AusNet Services Distribution Revised Regulatory Proposal  
2026-31

# REVIEW OF SELECTED AUGEX PROJECTS

Report prepared for:  
AUSTRALIAN ENERGY  
REGULATOR  
March 2026

Figure 4.35: Historical unserved energy arising from DSS faults due to thermal overload

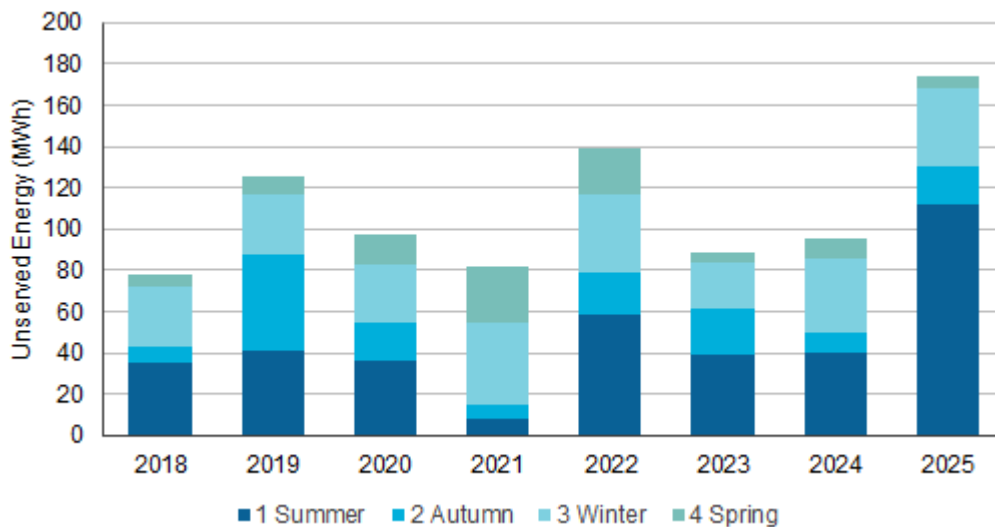
481. To improve our understanding of the situation, we sought further historical information. In Figure 4.35 we show the results of our analysis of this information. We observe that typically the amount of unserved energy due to DSS thermal overloads has been of the order of 100 to 110 MWh, with no clear upward trend up to 2024. The cause of the significantly higher value in 2025 can only be surmised, though it is possible that it may indicate the beginning of a trend increase that could be due to electrification.

Figure 4.36: Historical DSS faults due to thermal overload

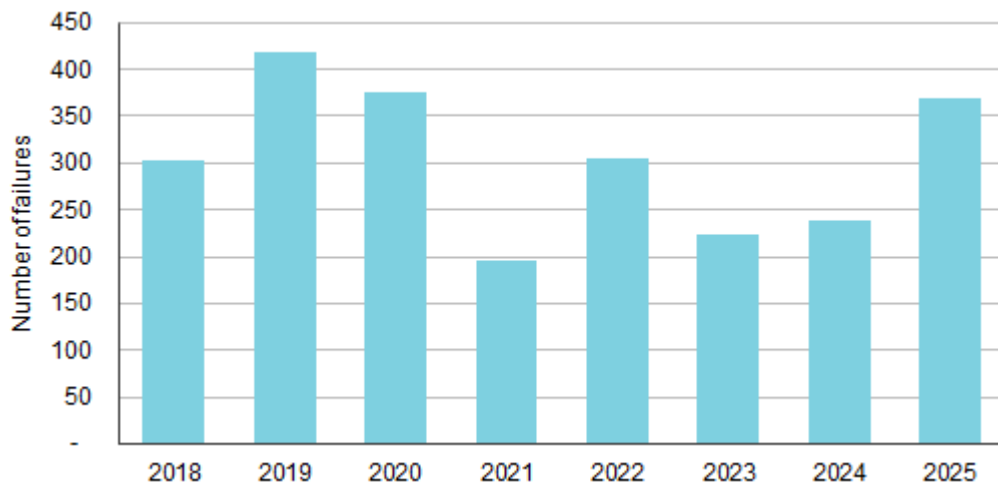
482. From AusNet’s data, we also determined the number of DSS faults that it ascribed to thermal overloads, which we show in Figure 4.36. This data similarly does not suggest an upwards trend and suggests that the higher unserved energy shown in Figure 4.35 for 2025 appears to be largely a function of presumed higher average unserved energy per fault and not an unusually high number of such faults.

Figure 4.37: Unserved energy ranked and grouped according to unserved energy, across distribution substations (DSS) that incurred outages/faults due to thermal overloads (2018 to 2025)

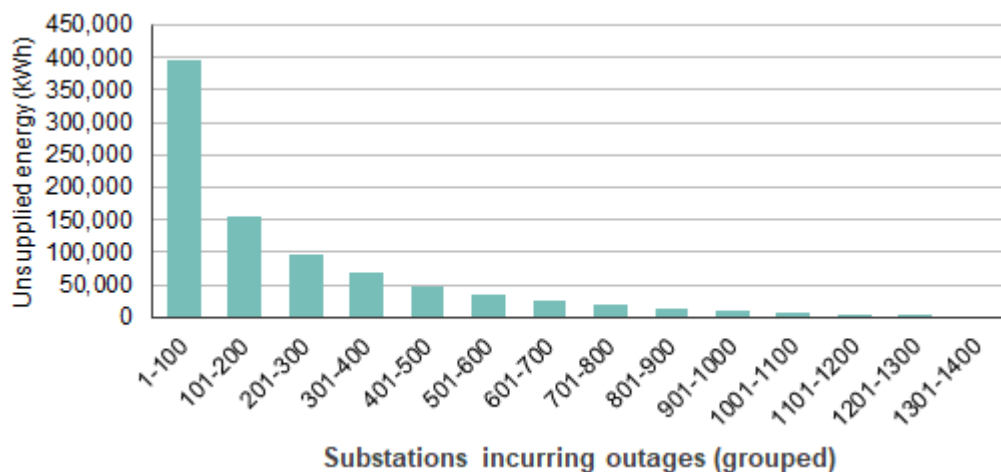
483. We also sought to understand from AusNet’s data, the distribution of unserved energy arising from the outages caused by thermal overload faults that occurred. As shown in Figure 4.37, we find that the unserved energy that AusNet has recorded as resulting from thermal overloads is highly concentrated in faults that occurred in a relatively small number of substations. Specifically:

Figure 4.38: AusNet’s modelled PVR against cumulative capex (\$m), for DSS

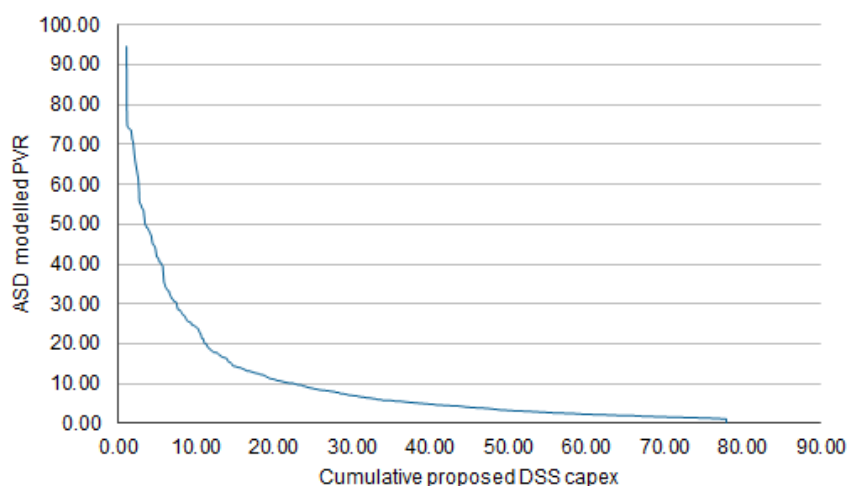
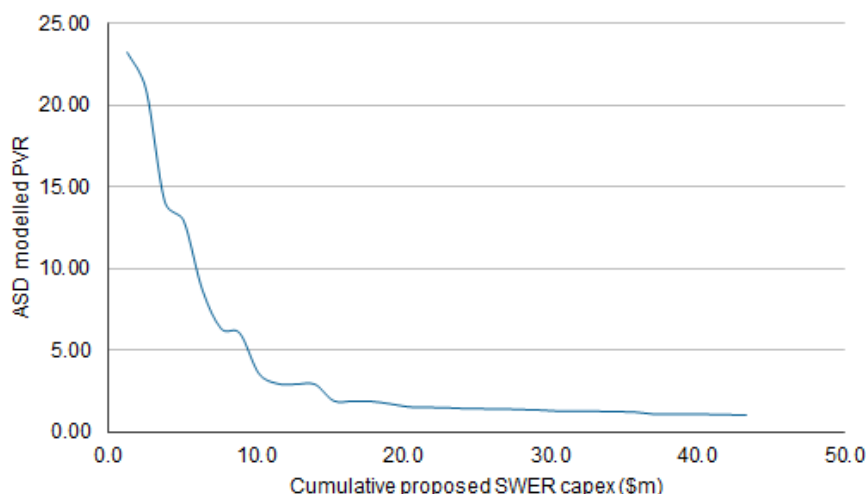
487. We present the results in Figure 4.38 (for DSS upgrades) and Figure 4.39 (for SWER upgrades). For the DSS upgrades, in order to provide visibility of the relationship, we have excluded the top six projects, which have PVRs of more than 100, with the largest having a PVR of more than 1,000 times.

488. While we stress that we consider that the economic analysis that leads to PVRs from AusNet's modelling are not a valid representation of the economics of the proposed projects, their relativities could be considered an indication of *relative* risk levels caused by thermal overloads. With this in mind, the results suggest that a small number of projects may at least be candidates to consider the merits of a pre-emptive upgrade. But the corollary to this is that there is a much larger number of projects (by value) for which the risk levels are less by factors of several times, or in some instances several orders of magnitude.
